SERVICE 		9
		X 89.113-26

MODELS **61, 66, 266, 268**

A NEW SILENCER WITH SPARK ARRESTOR - NEW SPIKE - NEW WRAP-AROUND HANDLE

61, 66, 266

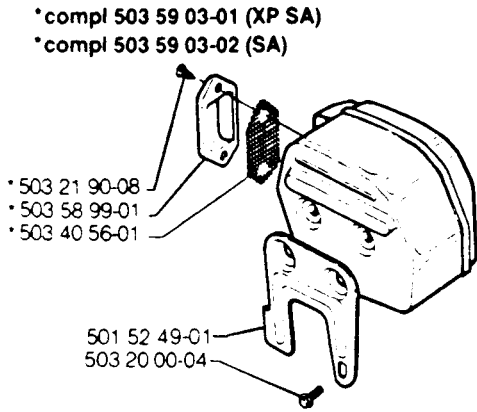
When changing to a new type of chain brake with knee link function Ref. No. compl. 503 57 28-01 and 503 57 28-03, anew silencer with so called spark arrestor, new spikes and new wrap-around handle are introduced also. The new chain brake can not be mounted on older saws which are not equipped with the new type of silencer with spark arrestor, new spikes and in some cases the new type of wrap-around handle. In that case the hand guard of the chainbrake will be destroyed and the saw can cause forest fire.

New Ref. No.	Description	Excluded Ref. No.	Remark
503 59 03-02	Silencer SA	501 65 77-01	61,66,266
501 65 76-01	Silencer	501 65 77-02	only 61
503 59 03-01	Silencer XP SA	501 65 77-03	only 266
503 59 07-01	Spike, outer	501 53 14-01	
503 59 08-01	Spike, inner	501 52 81-01	remains as a spare part
503 44 57-01	Flat bumper, inner	501 53 79-01	only 266, 268
503 59 09-01	Fiat bumper, outer		only 266, 268
503 44 44-01	Bushing	503 27 90-03	remains as a spare part
503 59 92-01	Silencer XP SA	503 40 55-02	only 268
503 59 92-02	Silencer SA	503 40 65-01	only 268
503 40 64-02	Silencer, jungle	503 40 55-01	only 268
503 58 62-01	Wrap-around handle	501 69 95-01	only 266, 268
503 58 63-01	Holder-spacer	501 69 97-01	only 266, 268
503 20 00-03	Screw		only 266, 268
503 22 65-01	Nut		only 266, 268
503 21 90-08	Screw, deflector	503 21 21-01	
503 58 99-01	Deflector	501 81 72-01	61,66,266
503 40 56-01	Screen	501 81 59-01	61,66,266
503 59 90-01	Deflector	503 40 57-01	only 268

266, 268

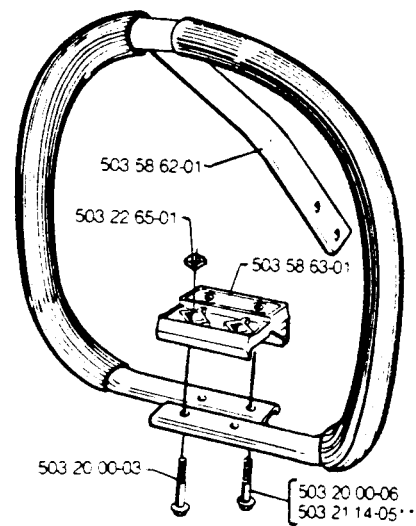
Note! The new wrap-around handle can only be mounted by using spacer Ref. No. 503 58 63-01.
